Giant Mine Environmental Assessment

Round Two Information Request Response

EA No. 0809-001

Yellowknives Dene First Nation IR #01

Figure 1 - Dispersion of Treated Effluent

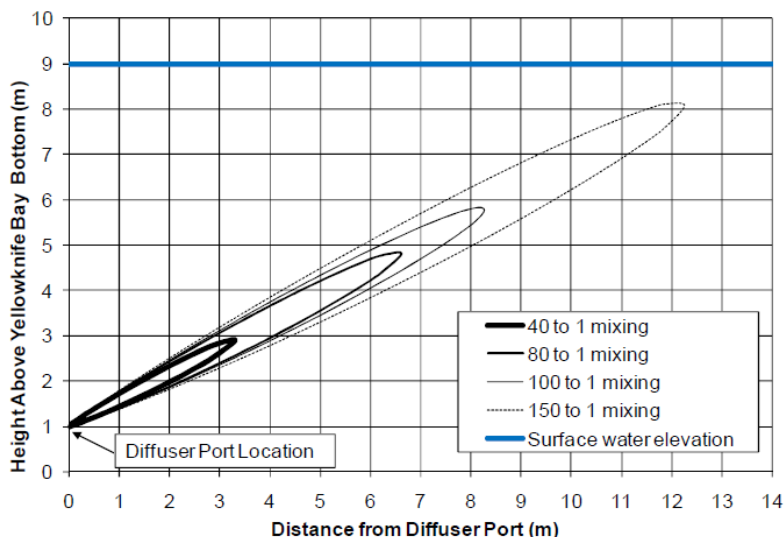
1. AANDC to define the acceptable water quality in the receiving environment by providing a list of parameters, and associated concentrations, that are protective of the receiving environment and evaluated through the MVEIRB process to understand potential impact to aquatic life. These will be called the water quality objectives. Presumably, if these water quality objectives are known, then the MVLWB could apply this knowledge in the determination of a regulatory limit that will achieve the objectives.

2. AANDC to compare the water quality objectives to the predicted water quality in the receiving environment.
3. AANDC to compare the (effluent) design specifications for its Water Treatment Plant and that planned for the Con Mine Site.

In comparing the predicted incremental effects on arsenic and the other constituents included in Table 1 to the water quality guidelines, it is seen that the predicted increases at the edge of the mixing zone fall below the guidelines for all constituents excepting arsenic. For example, with 100:1 mixing, the upper bound treated effluent discharge arsenic concentration of 0.5 mg/L, the guideline value of 0.005 mg/L would be met in a distance of less than 10 m from the outfall diffuser ports (note the incremental increase does not include the baseline arsenic concentration of 0.0003 mg/L (0.3 µg/L) present in the inflow from the Yellowknife River). The mixing of treated effluent in the vicinity of the diffuser is illustrated in Figure 1.

An important point to be kept in mind is that aquatic biota would not be acutely affected within the mixing zone as effluent toxicity testing of the current treated discharge has consistently been found to be non-toxic in acute toxicity tests.
